Access Compliance Report

Public Rights-of-Way

(Curb Ramps)

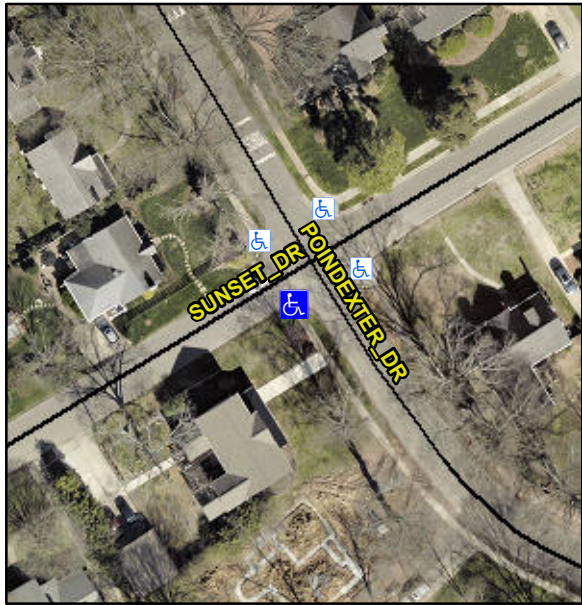
Intersection ID: 16042		Main Street: POINDEXTER_DR		Cross Street: SUNSET_DR		Location: S											
ADA ID: 9C322A21413A		Ramp Type: Directional1		Initial Pass/Fail: Fail		Overall Compliance: No		Severity Score: 1.25									
Codes/Mitigation Info/Possible Solution				Field Measurements/Component Compliance													
<div></div> <div>Possible Solutions:</div> <div>Remove & Replace Entire Ramp.</div> <div>Surveyor Notes:</div> <div>DAMAGED NO CURB, LNDG LIP 2.0", WTR VAL LNDG LIP 1.5"</div> <div>PROW/ADA:</div> <div>R304.5.3</div> <div>Street 1 NameSUNSET DR</div> <div>Stop Condition-Street 1StopSign</div> <div>Street 2 NameN/A</div> <div>Stop Condition-Street 2N/A</div> <div>Total Cost:\$1600.00</div>				Compliance		Description		Data		Compliance		Description		Data			
				N/A		Ramp Length (in)		77.0		N/A		Grade Break?		N/A			
				Yes		Ramp Width (in)		48.0		N/A		Grade Break Slope (%)		0.0

Yes		Ramp Slope (%)		6.1		N/A		Grade Break XSlope (%)		0.0			
				No		Ramp XSlope (%)		4.8									
				N/A		Flare Type LT		N/A		N/A		Flare Type RT		N/A			
				N/A		Flare Slope LT (%)		N/A		N/A		Flare Slope RT (%)		0.0			
				N/A		Flare Traversable LT?		N/A		N/A		Flare Traversable RT?		N/A			
				N/A		Landing Length (in)		0.0		N/A		DWS Provided?		N/A			
				N/A		Landing Width (in)		0.0		N/A		DWS Contrast?		N/A			
				N/A		Landing Slope (%)		0.0		N/A		DWS Length (in)		N/A			
				N/A		Landing X Slope (%)		0.0		N/A		DWS Full Width?		N/A			
				N/A		Landing Curb? (Y/N)		N/A		N/A		DWS Offset LT (in)		N/A			
				N/A		Shared Landing?		N/A		N/A		DWS Offset RT (in)		N/A			
				N/A		Gutter Ponding?		0.0		N/A		Gutter Slope (%)		N/A			
				N/A		Gutter Lip Ht (in)		0.0		N/A		Gutter X Slope (%)		N/A			
				N/A		Painted X Walk1?		No				Road Slope (%)		4.1			
						X Walk 1 Direction		To NW				Road X Slope (%)		1.4
